Re: Foreshore licence application FS007134 Sea Stacks Offshore Wind ESB

Objection to Application for Site Investigation Licence ref: FS007134

Figure 1.2 - Foreshore Licence Area proposed by ESB Wind Development Limited (in red)

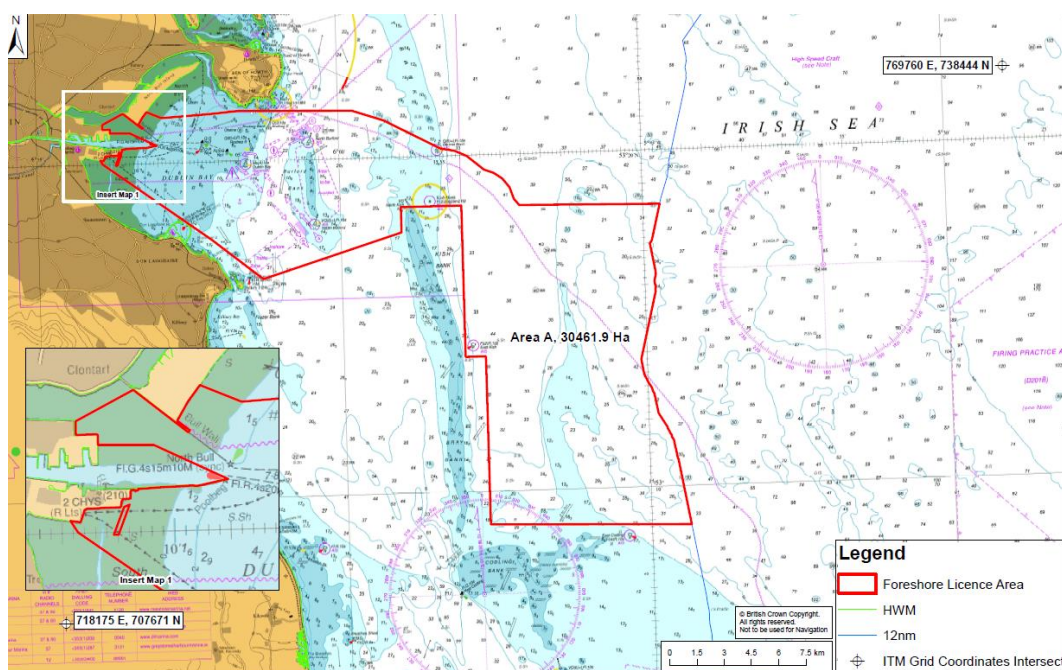
- 1.5 It is submitted that circa 80% of the Foreshore Licence Area proposed by ESB (see Figure 1.2) under the FLA SS FS007134 Application overlaps with the Foreshore Licence Area proposed by Ocean Winds (see Figure 1.1) under the Réalt na Mara FS007330 Application. Specifically, the array investigation area proposed by ESB falls wholly within the Foreshore Licence Area proposed by OW Ireland for the Réalt na Mara Project under the Réalt na Mara FS007330 Application. In addition, the cable investigation area proposed by ESB covers a significant portion of one of the potential cable route options for the Réalt na Mara Project located in the Northern Area at Poolbeg Substation.
